R. R. Sgarro  
Manager, Nuclear Regulatory Affairs

**BELL BEND NUCLEAR POWER PLANT  
RESPONSE TO ENVIRONMENTAL  
REQUESTS FOR ADDITIONAL  
INFORMATION, FOURTH SUBMITTAL  
BNP-2009-266      Docket No. 52-039**

Response Status for Environmental Requests for Additional Information  
Bell Bend Nuclear Power Plant  
Luzerne County Pennsylvania

Responses to Environmental Requests for Additional Information  
Bell Bend Nuclear Power Plant  
Luzerne County Pennsylvania

Table 2

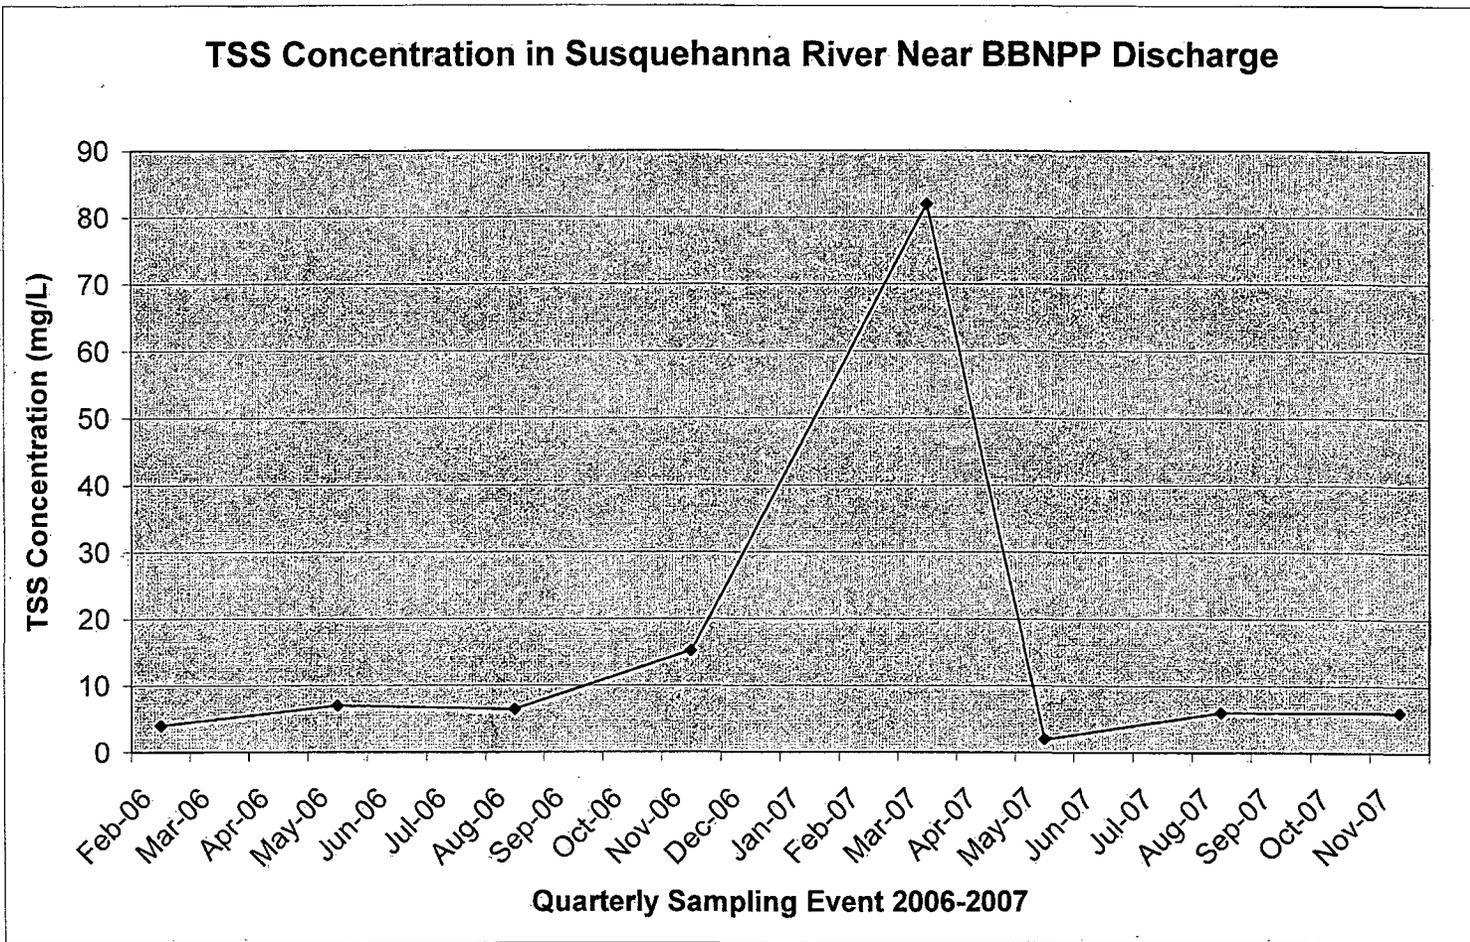
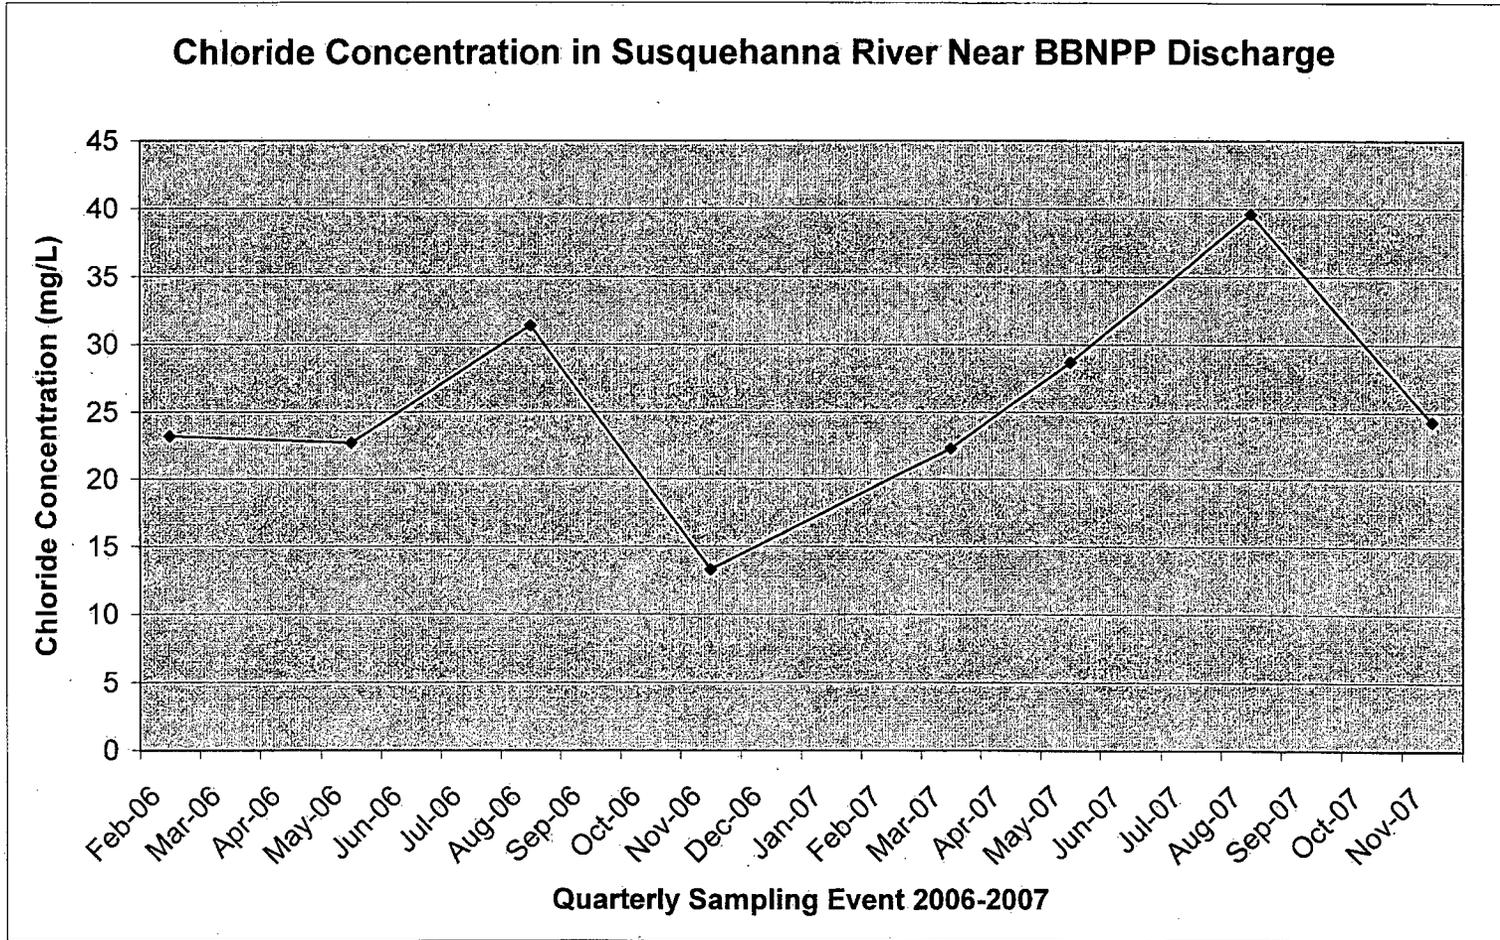
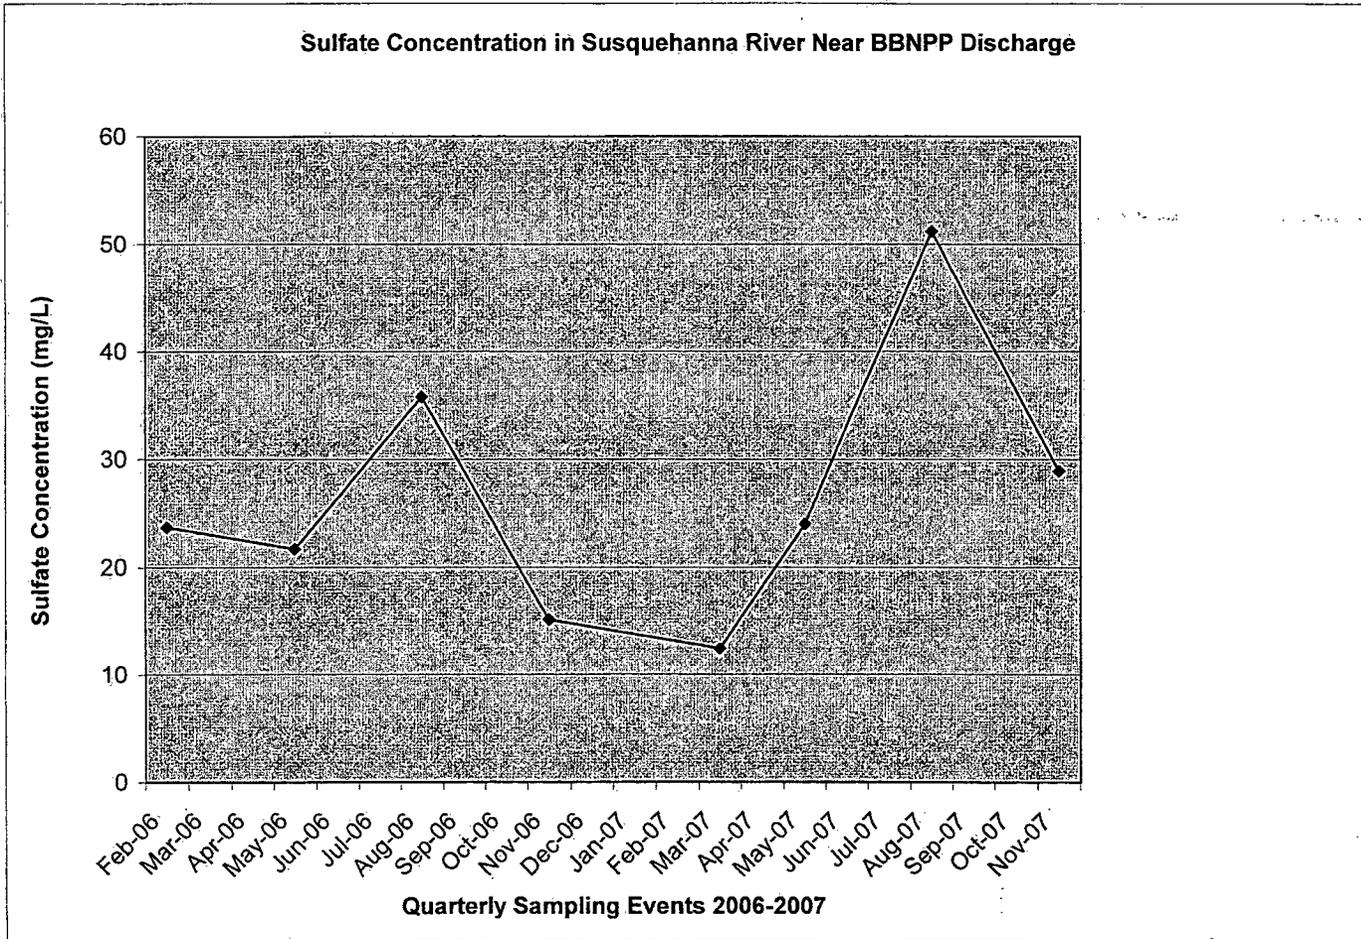
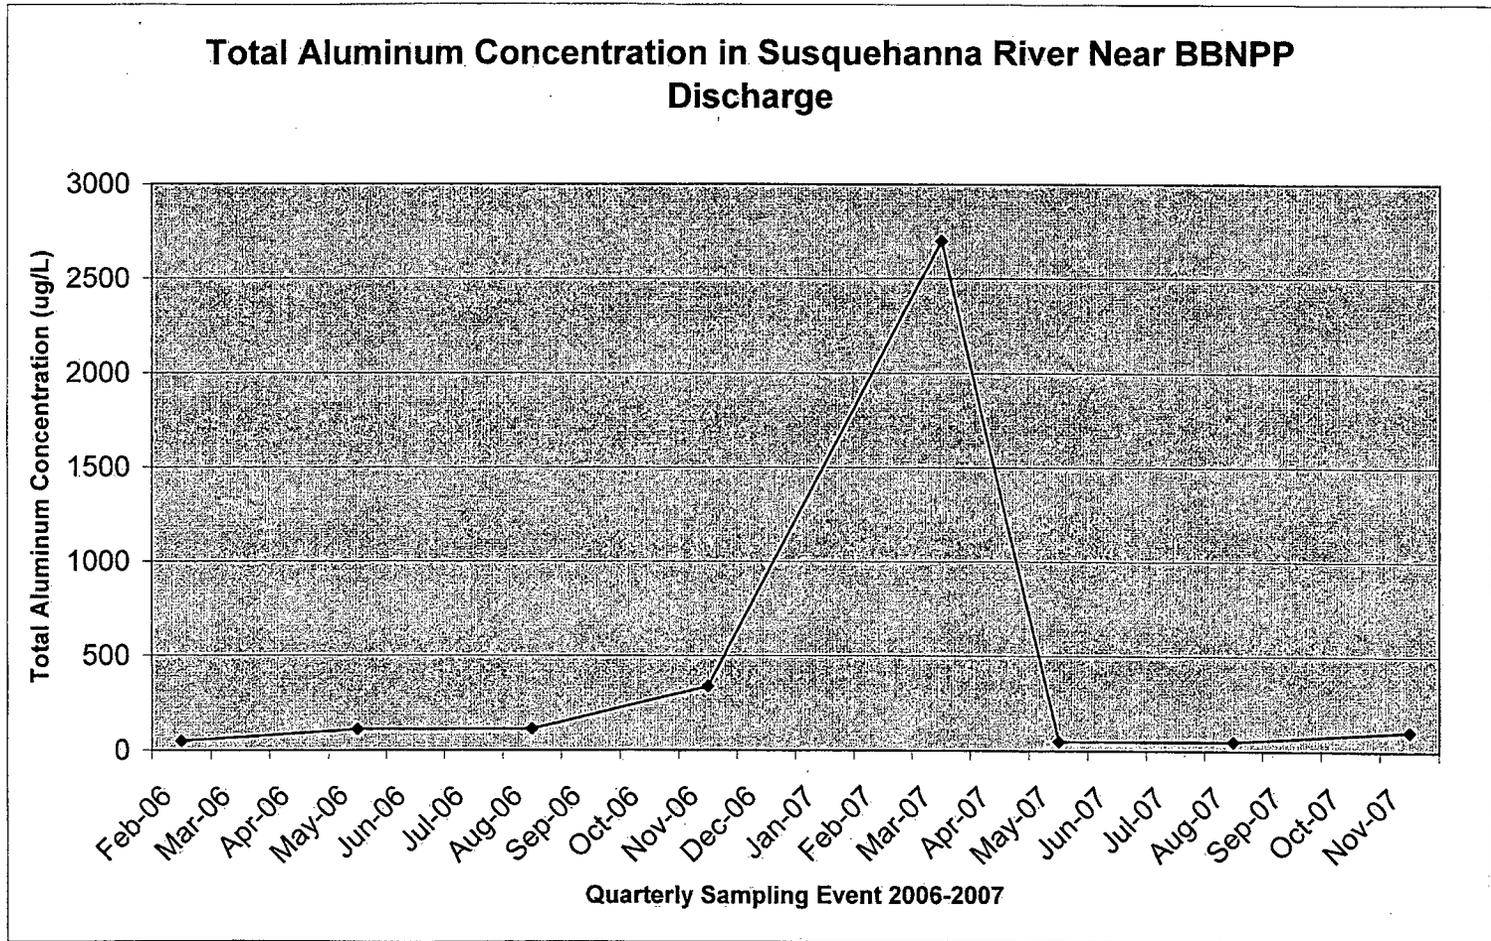
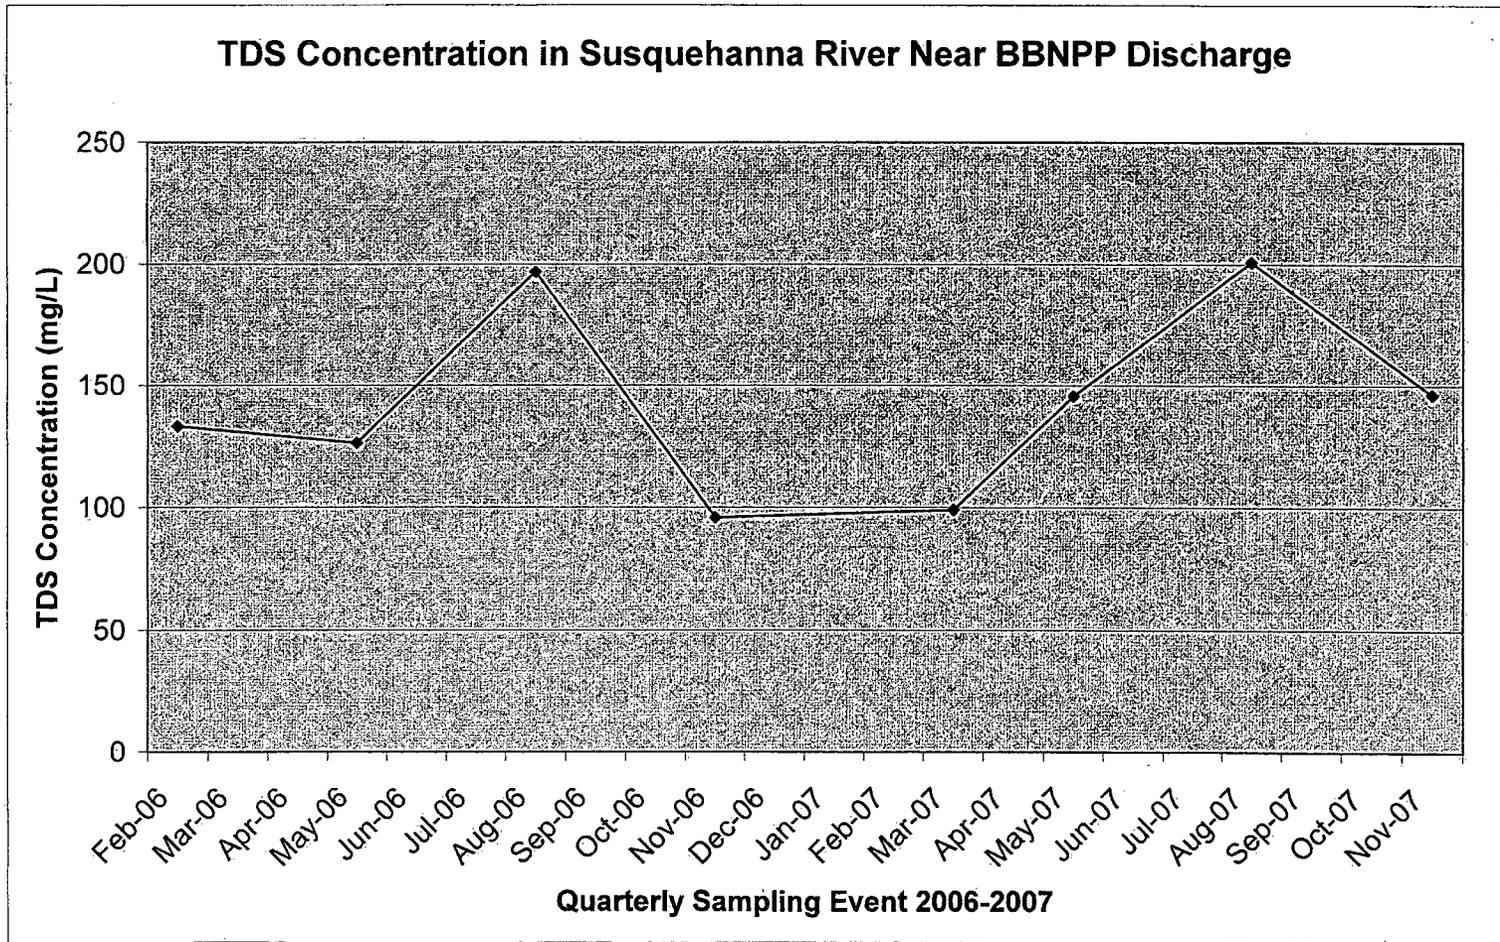
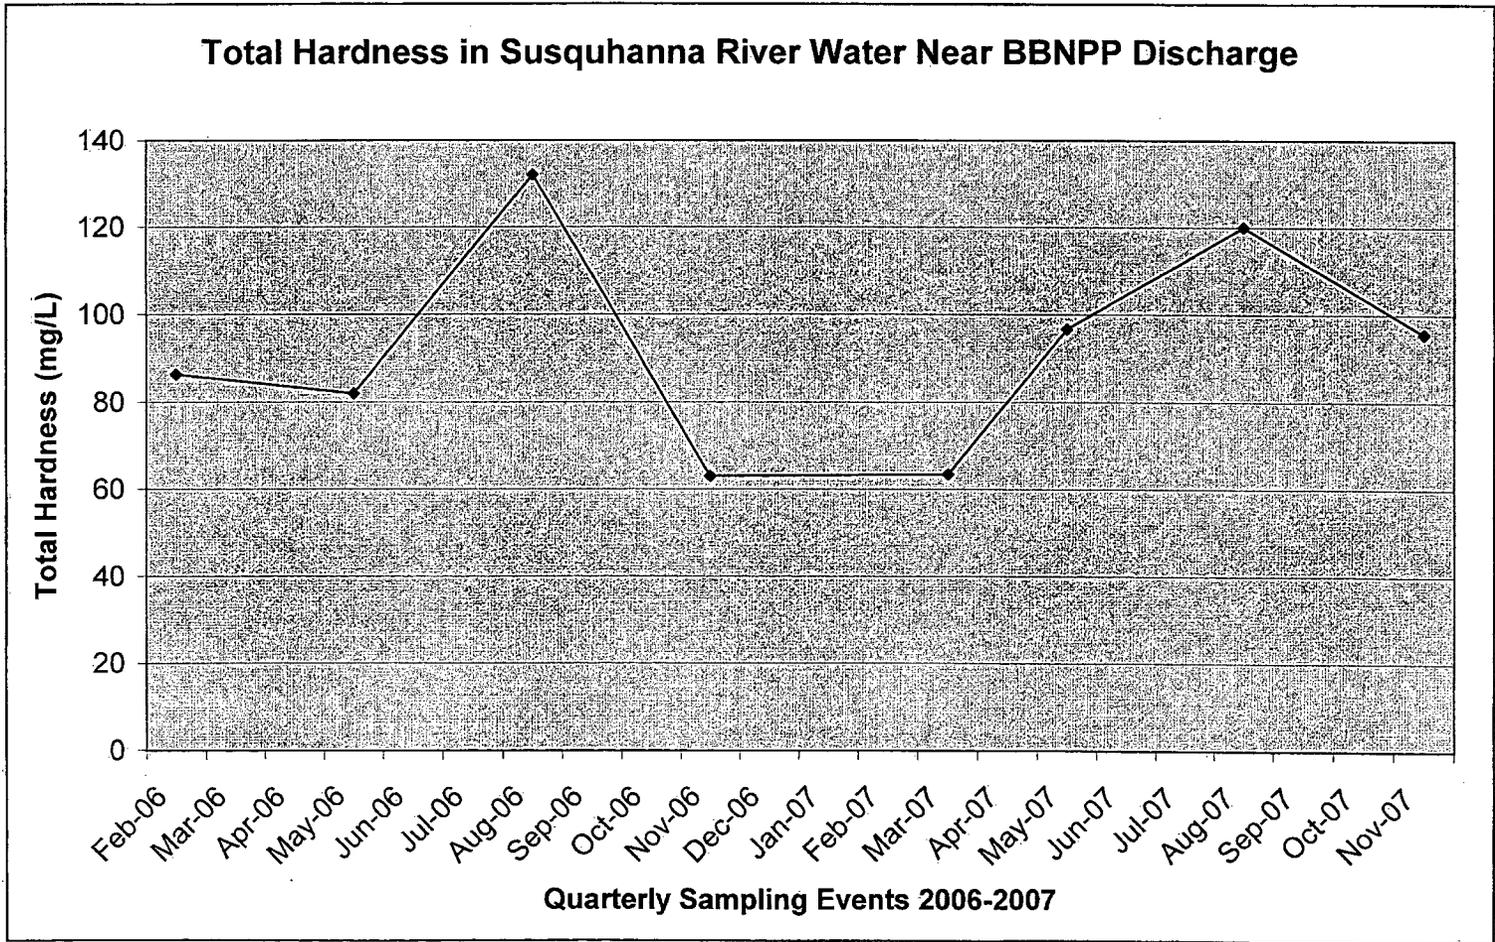
**Summary:** *Provide supplemental information on the intake source water quality data presented in ER Table 3.6-3. Include information on seasonal values of chemical analytes in intake and receiving waters.*

Table 2, Susquehanna River Water Quality at Discharge, and associated charts show the river water quality in the vicinity of the planned discharge location (the receiving water). This table and charts presents the river sampling data for the same quarterly sampling events as the "intake" water discussed above. The sampling location is downstream of the SSES discharge.
